RE: **Enterprise Rent-a-Car**
3500 Coors Blvd NW
Grading and Drainage Plan
Engineer's Stamp Date: 1/29/19
Hydrology File: G11D038

Based on the submittal received on 2/15/19, the Grading and Drainage Plan is approved for Building Permit.

PROJECT TITLE ENTERPRISE RENT-A-CAR 3500 COORS BLVD NW ALBUQUERQUE, NEW MEXICO 87120	JOB NO. 2018028	DRAWN BY: RC	SHEET TITLE Grading Plan
DATE 1/29/2019	SCALE AS NOTED	SHEET NO. C2.1	OF 1

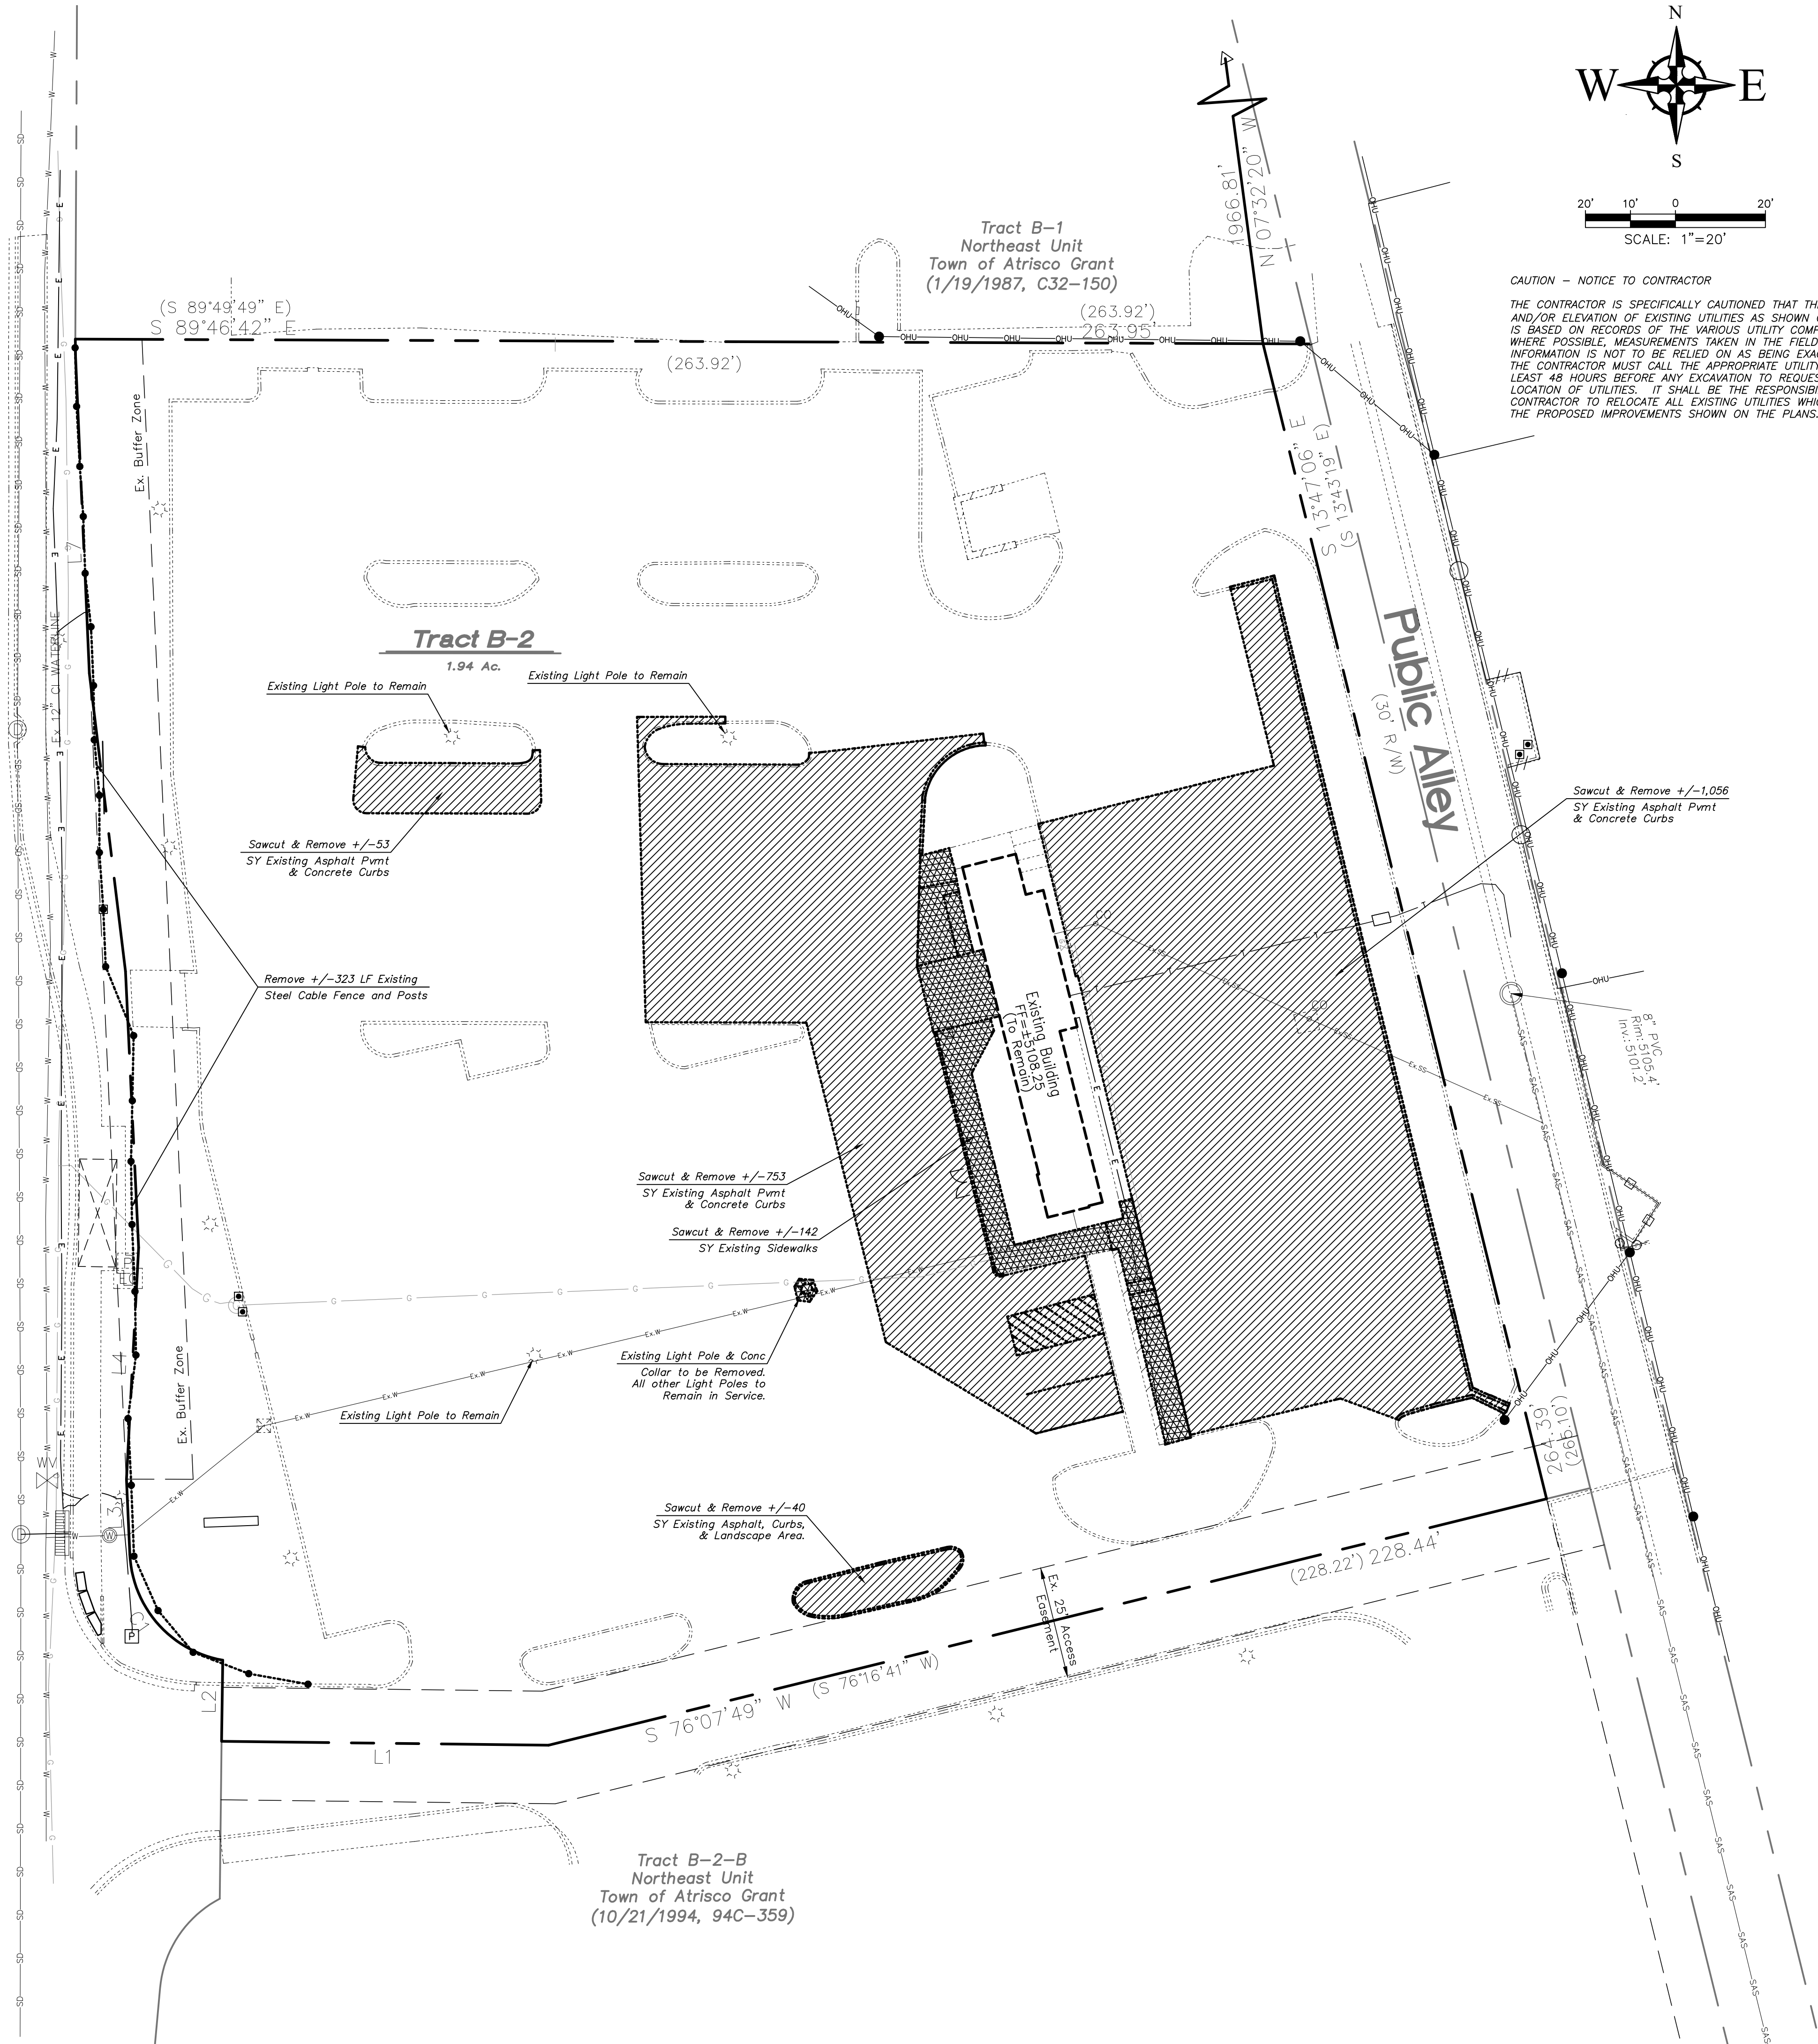
Prior to Certificate of Occupancy (For Information):

1. Engineer's Certification, per the DPM Chapter 22.7: *Engineer's Certification Checklist For Non-Subdivision* is required.
2. A Bernalillo County Recorded [Drainage Covenant \(No Public Easement\)](#) is required for the stormwater control pond and the existing Stormwater Quality Pond. The original notarized form, exhibit A (legible on 8.5x11 paper), and recording fee (\$25, payable to Bernalillo County) must be turned into DRC (4th, Plaza del Sol) for routing. Please contact Charlotte LaBadie (clabadie@cabq.gov, 924-3996) or Madeline Carruthers (mtafoya@cabq.gov, 924-3997) regarding the routing and recording process for covenants. The routing and recording process for covenants can take a month or longer; Hydrology recommends beginning this process as soon as possible as to not delay approval for certificate of occupancy.
